SUBJECT: Contract 008066
SR 520, Floating Bridge and Landings Project
Federal Aid No. BR-0520(047)
Change Order No. 122 – PPDB Revisions

**WASHINGTON STATE
DEPARTMENT OF TRANSPORTATION
CHANGE ORDER**

CONTRACT NO: 008066 FEDERAL AID NO: BR-0520(047)
CONTRACT TITLE: SR 520 / I-5 TO MEDINA - EVERGREEN POINT FLOATING
CHANGE ORDER NO: 122 R1 PPDB REVISIONS

APPENDIX M22
 PONTOON
 MINIMUM TECHNICAL REQUIREMENTS
 KEEL SLAB PLAN

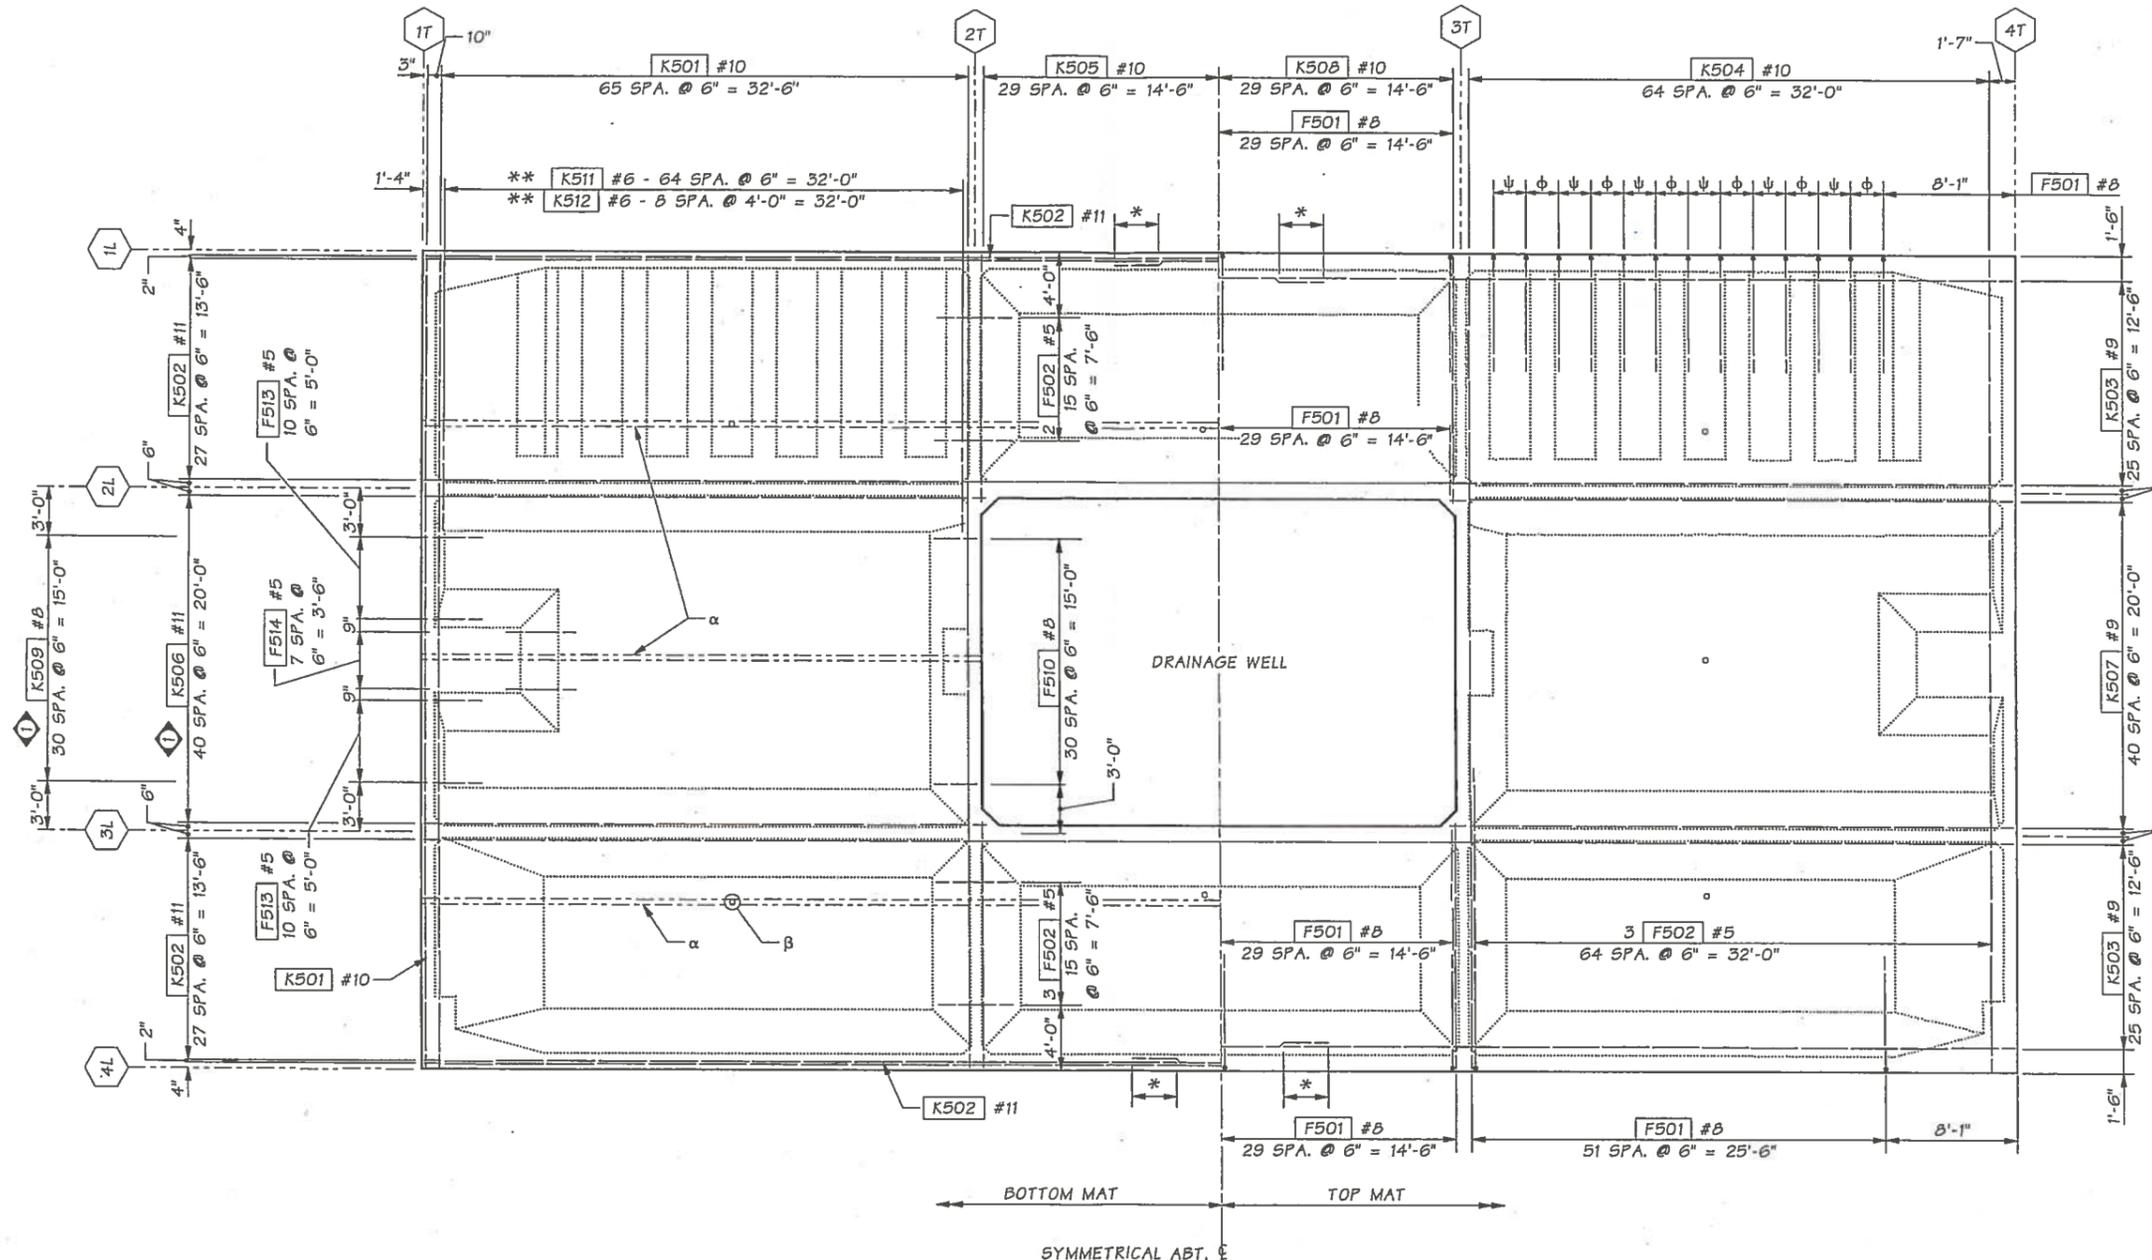
Bridge Design Engr.	Khaleghi, B	M:\W-Team\SR 520 FLOATING BRIDGE\M22 PMTR>window files\5502-KEEL PLAN.wnd			
Supervisor	Clarke, PT	REGION NO.	STATE	FED. AID PROJ. NO.	SHEET NO.
Designed By	ADM, PFS 11/10	10	WASH.		TOTAL SHEETS
Checked By	EJF, PFS 03/11	AD23 - REV. BAR MARKS			
Detailed By	Gun's, E 11/10	AD15 - REV. & ADDED REINF.			
Bridge Projects Engr.		REMOVED STRUCT. P.T.			
Prelim. Plan By		DATE	REVISION	BY	APPD
Architect/Specialist

APPENDIX M22 PONTON MINIMUM TECHNICAL REQUIREMENTS
 DETAILS 3

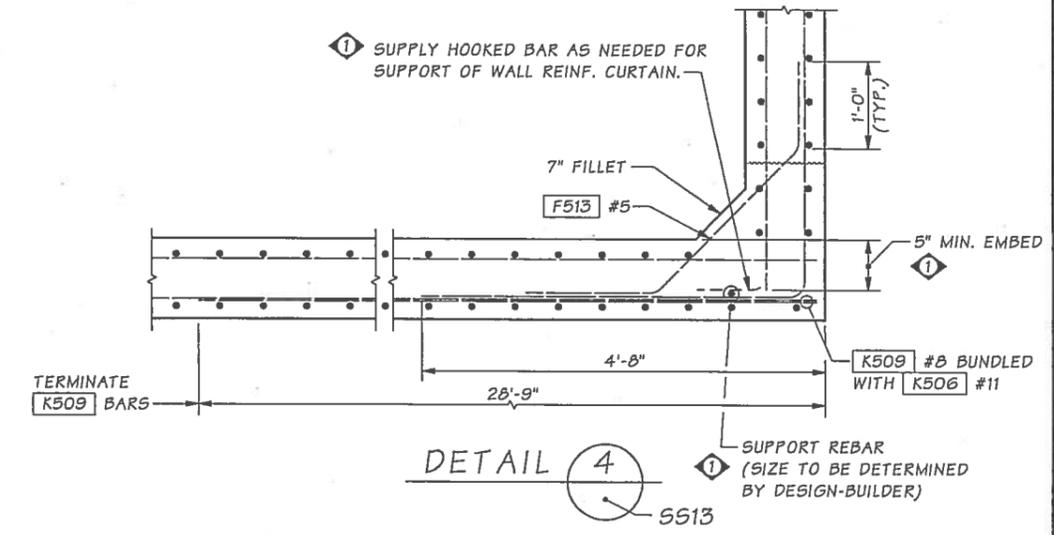
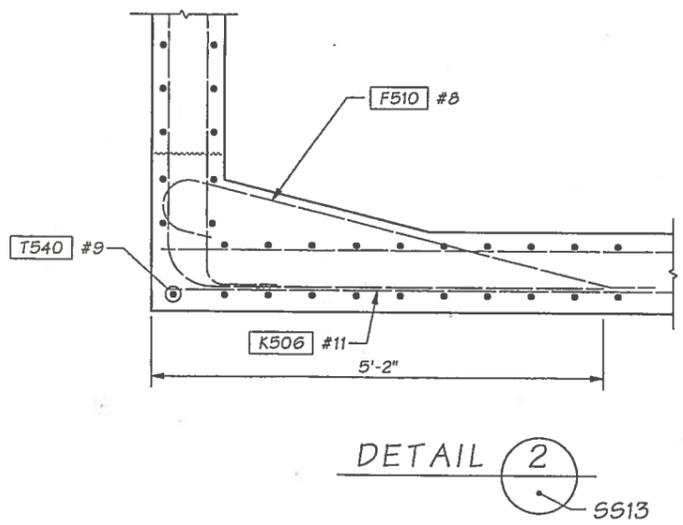
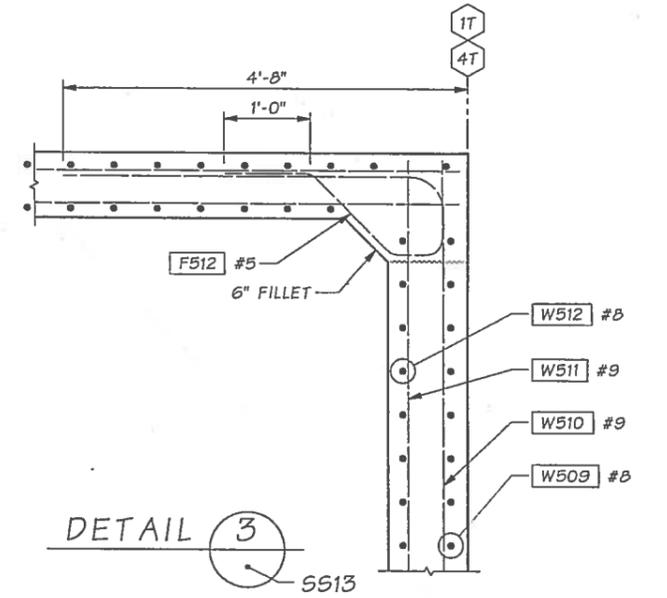
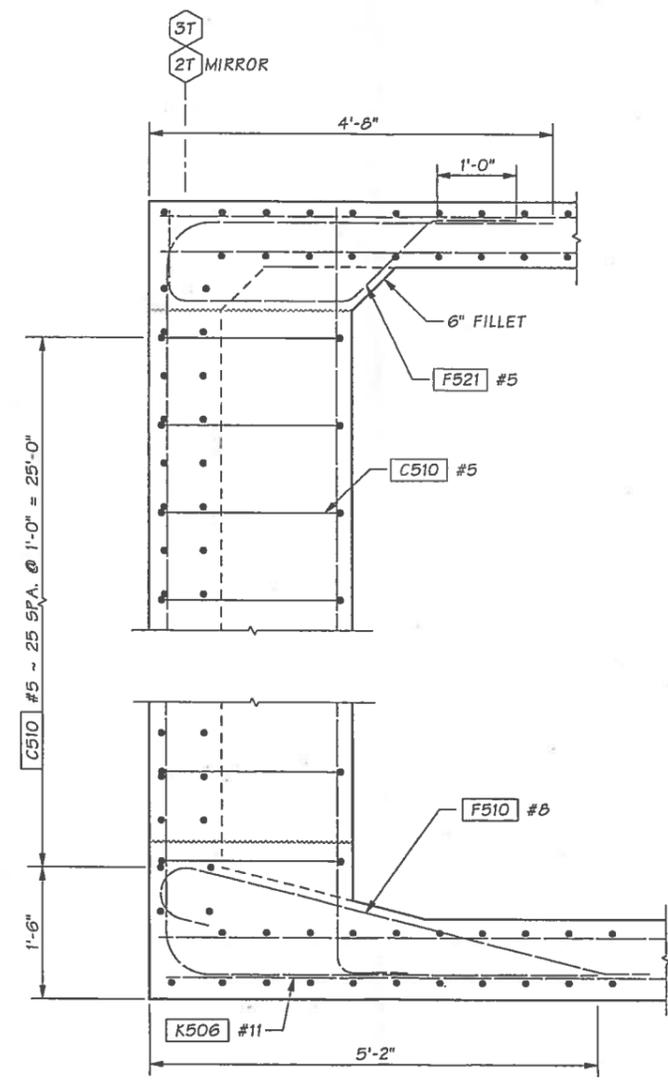
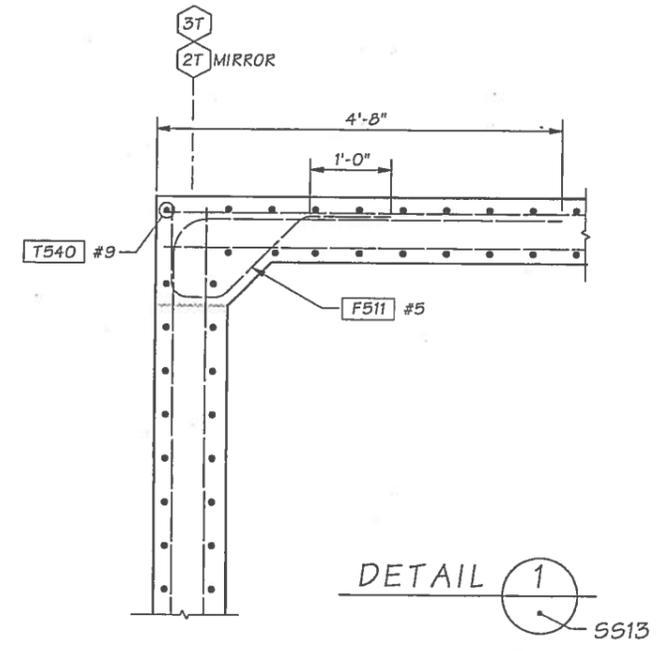
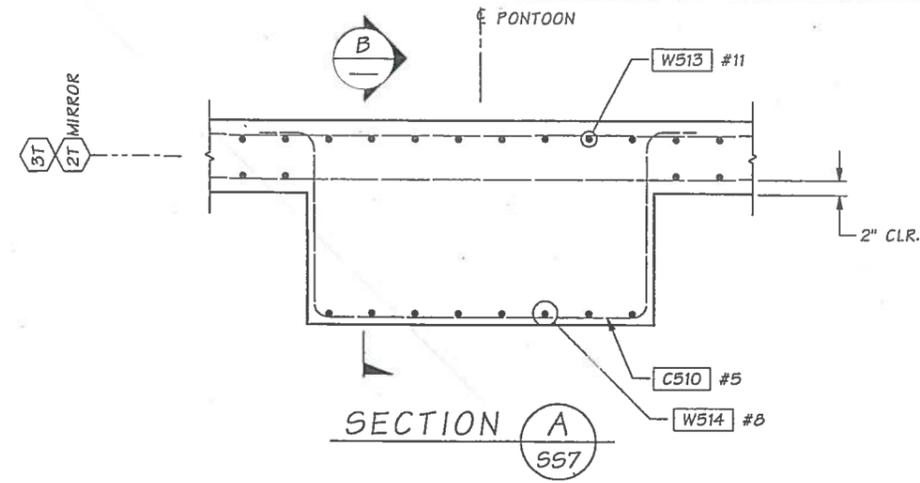
Bridge Design Engr.	Khaleghi, B	M:\W-Team\SR 520 FLOATING BRIDGE\M22 PMTR>window files\5519-DET 3.wnd			
Supervisor	Clarke, PT	REGION NO.	STATE	FED. AID PROJ. NO.	SHEET NO.
Designed By	Spitznas, P	10	WASH.		TOTAL SHEETS
Checked By	Ferluga, E				
Detailed By	Gun's, E				
Bridge Projects Engr.		DATE	REVISION	BY	APPD
Prefim. Plan By		05/2011	AD23 - REVISED BAR MARK	EJF	
Architect/Specialist		03/2011	AD15 - REVISED SECTIONS & DETAILS	ADM

APPENDIX M22
 PONTOON
 MINIMUM TECHNICAL REQUIREMENTS
 DETAILS 4

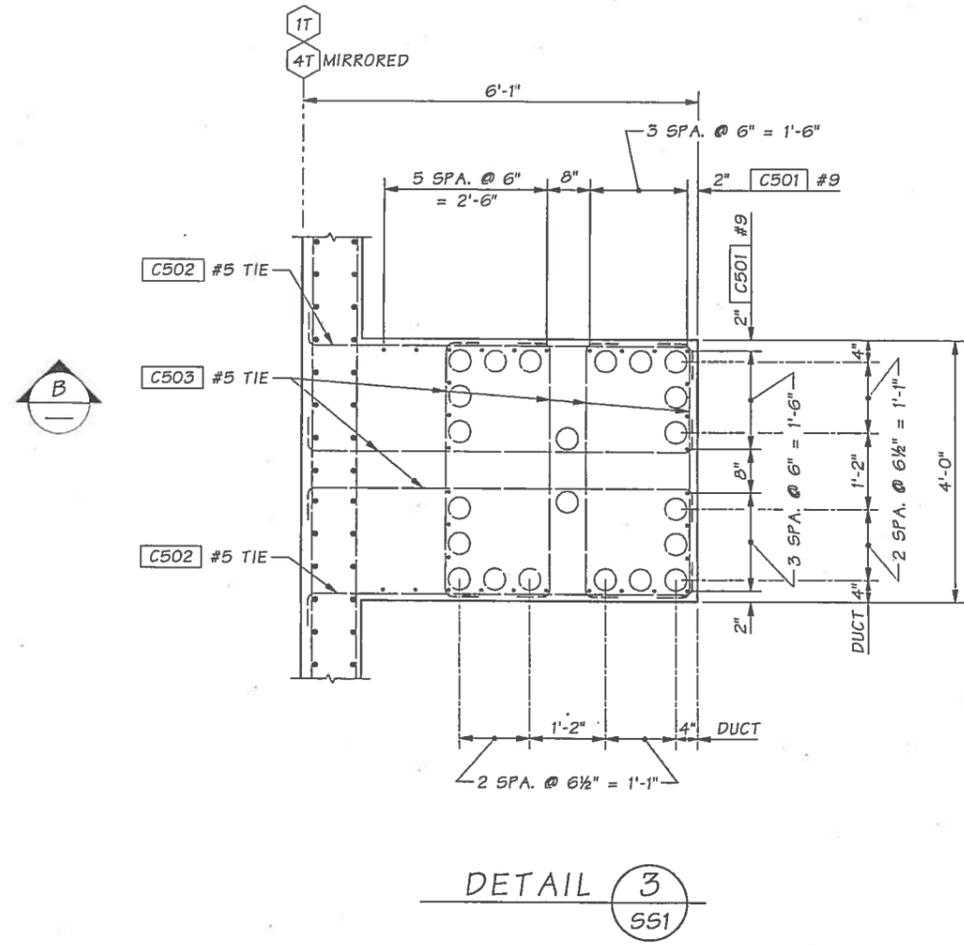
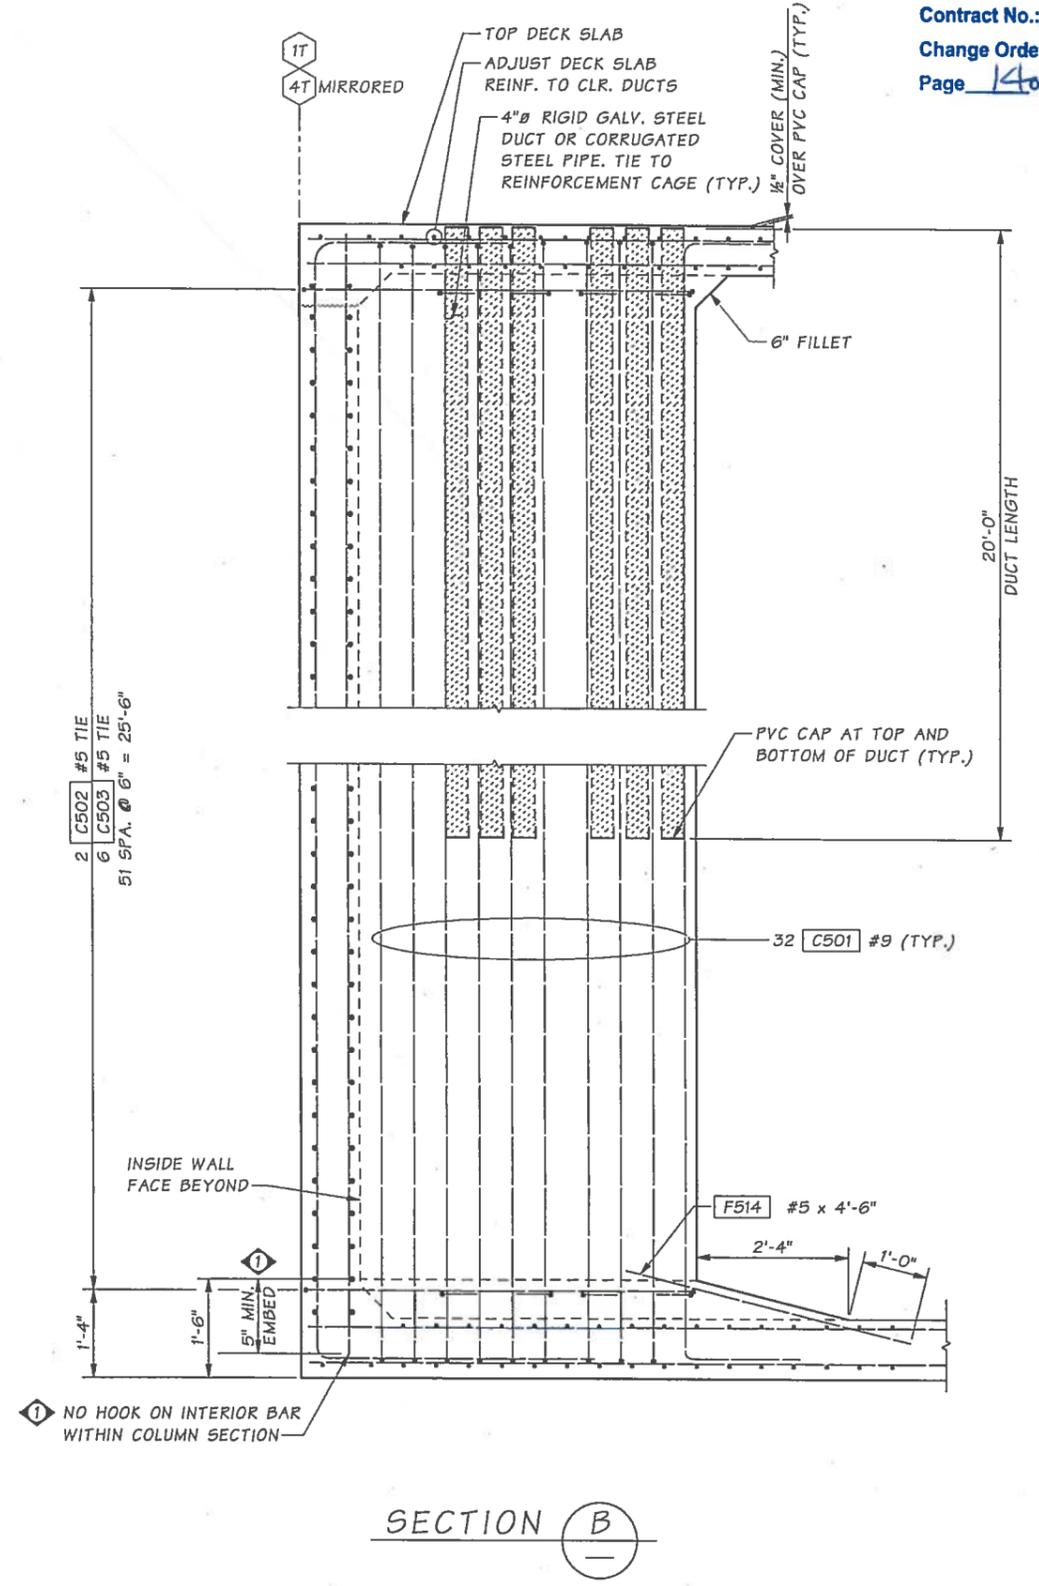
Bridge Design Engr.	Khaleghi, B	M:\W-Team\SR 520 FLOATING BRIDGE\M22 PMTR>window files\5520-DET 4.wnd			
Supervisor	Clarke, PT	REGION NO.	STATE	FED. AID PROJ. NO.	SHEET NO.
Designed By	Spitznas, P	10	WASH.		TOTAL SHEETS
Checked By	Ferluga, E	JOB NUMBER 10A057			
Detailed By	Gunis, E	DATE	REVISION	BY	APP'D
Bridge Projects Engr.	11/2012	REV. BAR TO RELIEVE CONGESTION	EJF		
Prelim. Plan By	03/2011	AD15 - REVISED SEC. B & BAR NUMBERS	ADM		
Architect/Specialist

APPENDIX M22
 PONTOON
 MINIMUM TECHNICAL REQUIREMENTS
 DETAILS 9

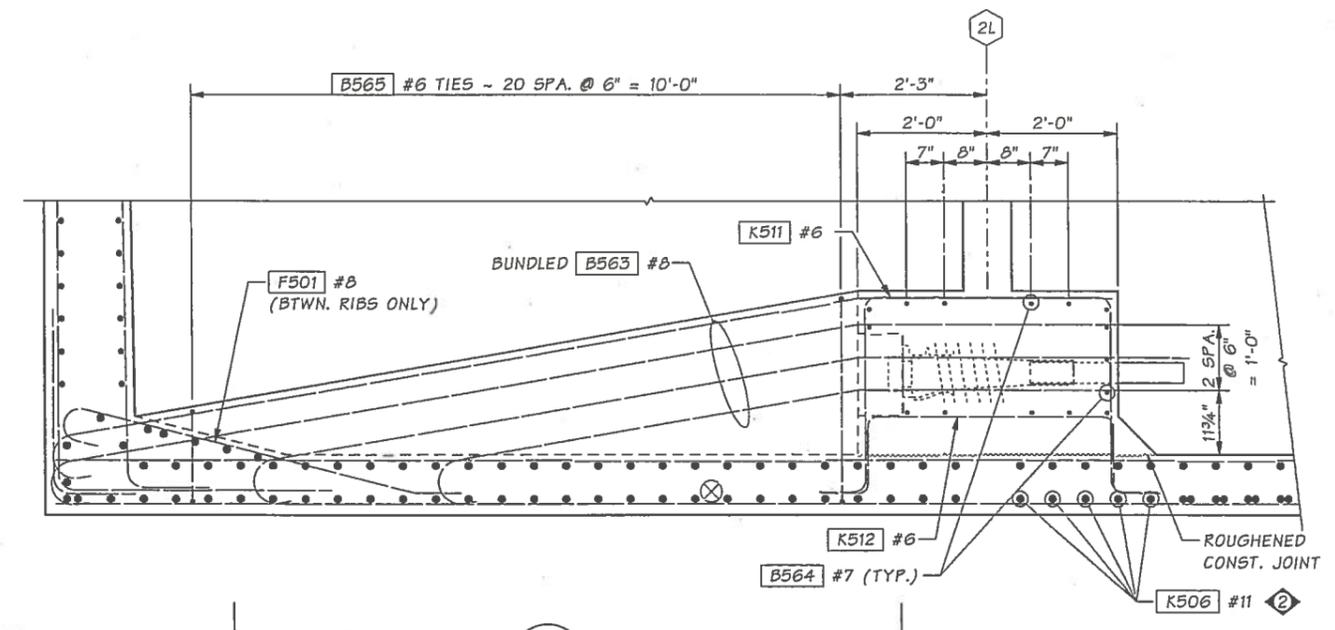
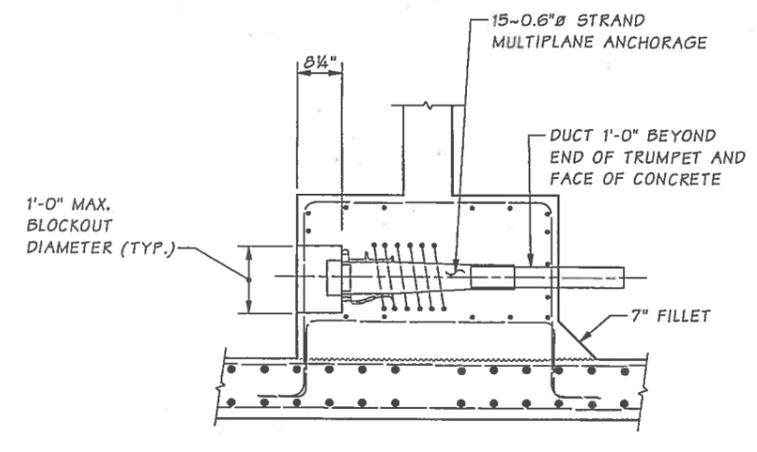
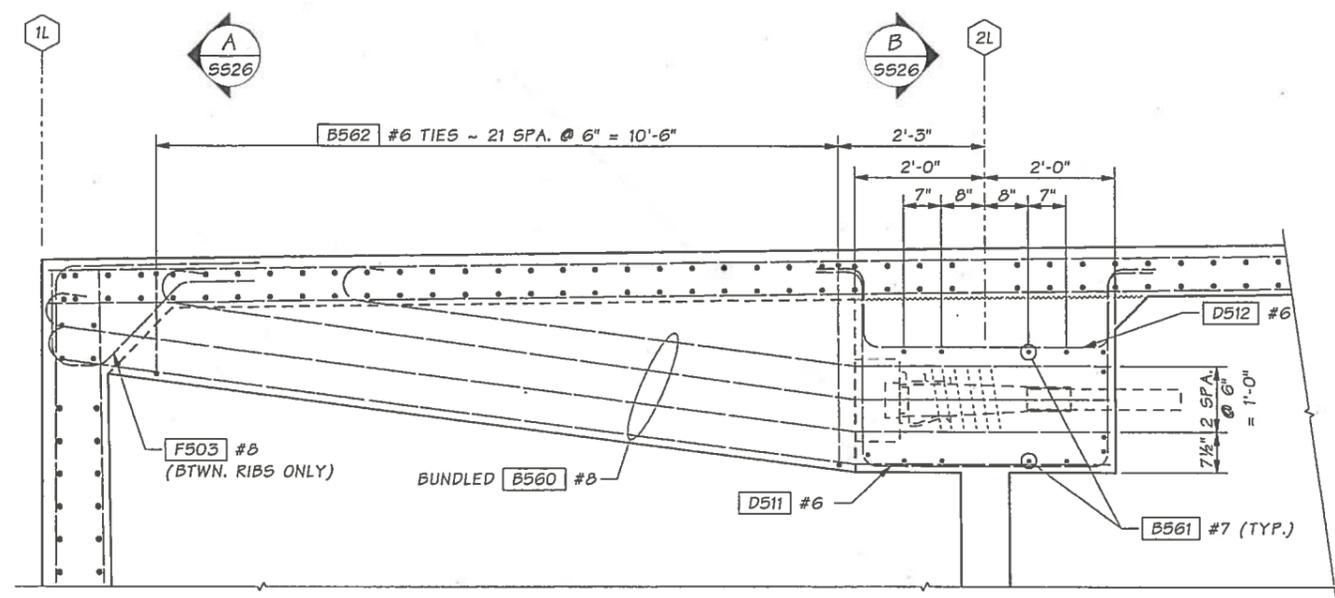
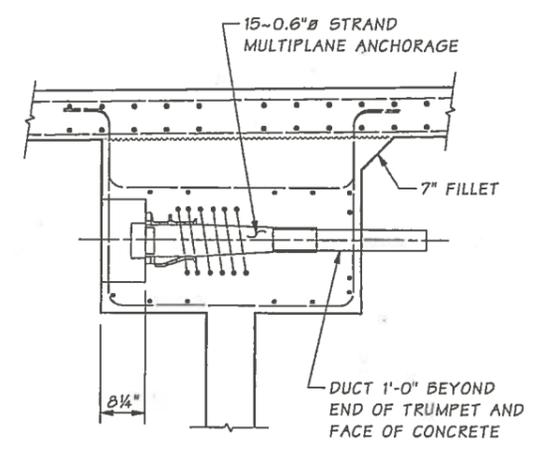
Bridge Design Engr.	Khaleghi, B	M:\W-Team\SR 520 FLOATING BRIDGE\M22 PMTR>window files\5525-DET 9.wnd		REGION NO.	STATE	FED. AID PROJ. NO.	SHEET NO.	TOTAL SHEETS
Supervisor	Clarke, PT			10	WASH.			
Designed By	Messmer, A	11/10						
Checked By	Spitznas, P	03/11	11/2012	Ⓢ OMIT [K509] TO RELIEVE CONGESTION		EJF		
Detailed By	Gunis, E	11/10	10/2011	Ⓢ REV. # BARS PER RFI #4		ADM		
Bridge Projects Engr.			05/2011	AD21 - ADDED DIM.		ADM		
Prelim. Plan By			03/2011	AD15 - REMOVE STRUCT. PT.		ADM		
Architect/Specialist			DATE	REVISION	BY	APPD
